SPRING HILL BUSINESS PARK SUBDIVISION, PHASE TWO

APPLICATION NUMBER 11 DATE December 18, 2008
APPLICANT Spring Hill Business Park Subdivision, Phase Two
REQUEST Subdivision

DETAIL SITE PLAN

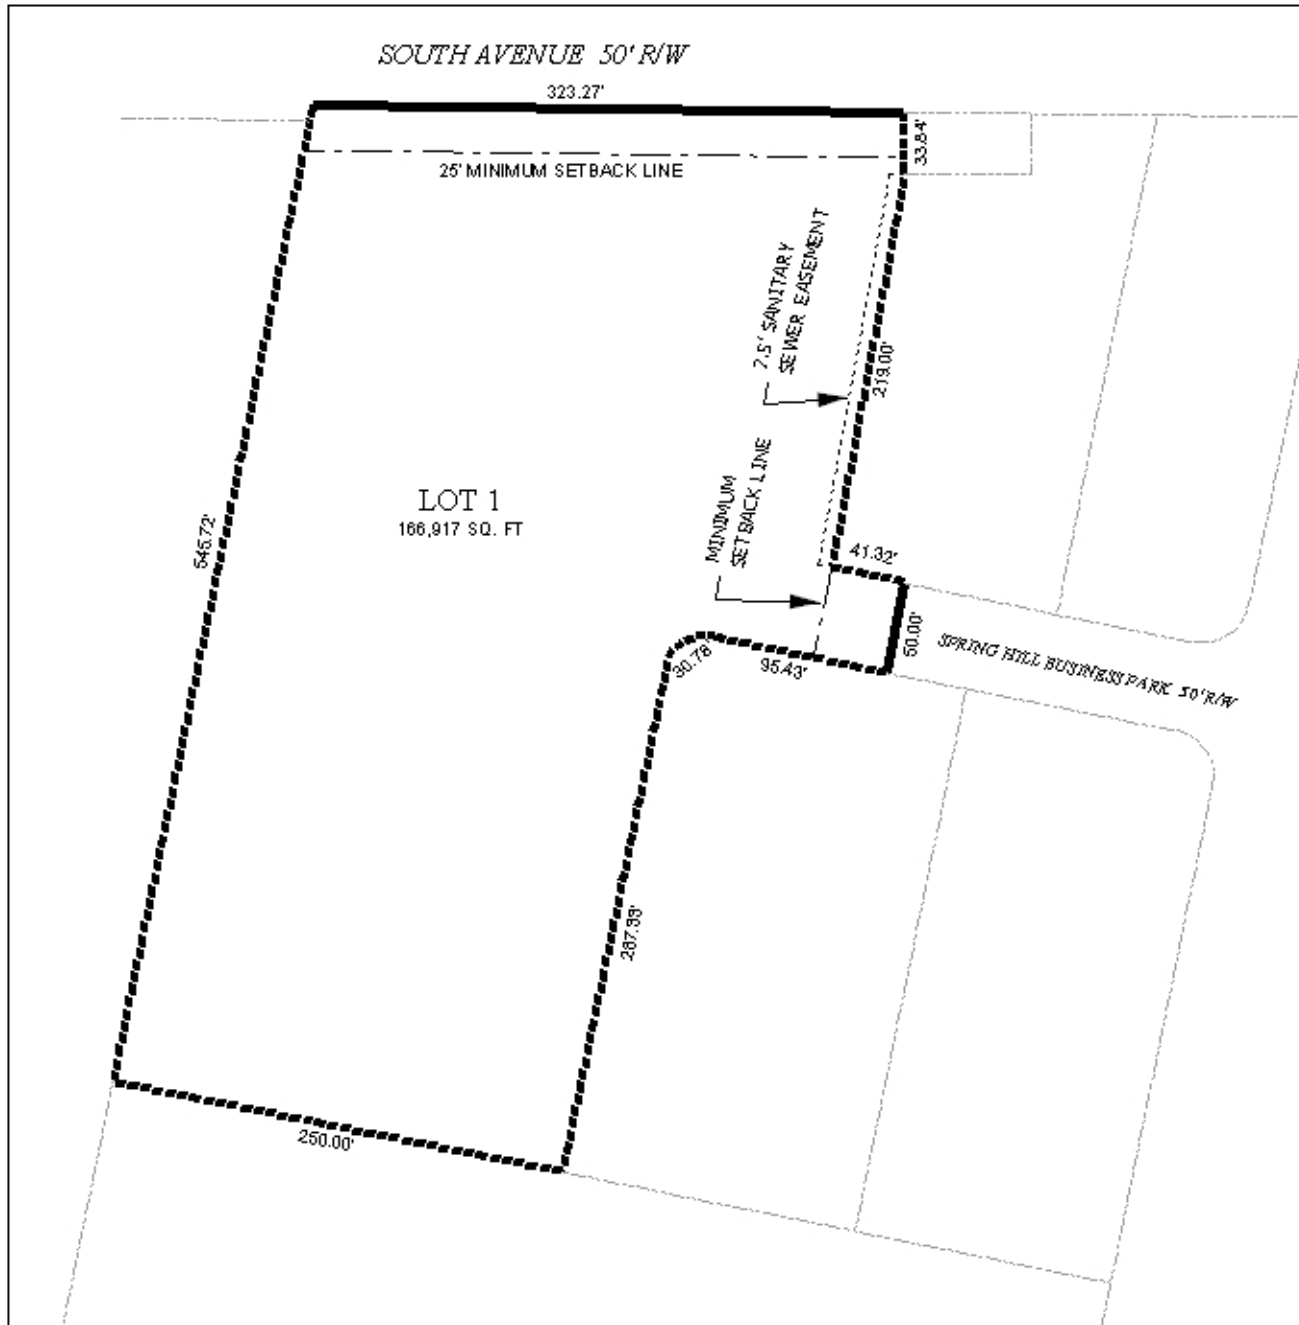
It appears from the plat submitted that Spring Hill Business Park is approximately 206' in length and dead ends into proposed Lot 1. According to the 2003 International Fire Code, streets longer than 150' are required to have a cul de sac of appropriate size for fire trucks to turn around. It should also be noted that the original subdivision plan submitted in 1992 included a cul de sac. The plat should be revised to include a cul de sac where Spring Hill Business Park dead ends into proposed Lot 1. The 25' minimum building setback line should also be revised accordingly.

Proposed Lot 1 would have approximately 323' of frontage along South Avenue however; due to the residential nature of the street, a note should be placed on the final plat stating that Lot 1 is denied access to South Avenue.

- 1) Revision of the plat to include construction and dedication of a compliant cul de sac where Spring Hill Park dead ends into proposed Lot 1;
- 2) Revision of the plat to show a 25' minimum building setback line back from all new street frontages;
- 3) Placement of a note on the final plat stating that Lot 1 is denied access to South Avenue; and
- 4) Placement of a note on the final plat stating that approval of all applicable Federal, state and local agencies is required for wetland and floodplain issues, if any, prior to the issuance of any permits or land disturbance activities
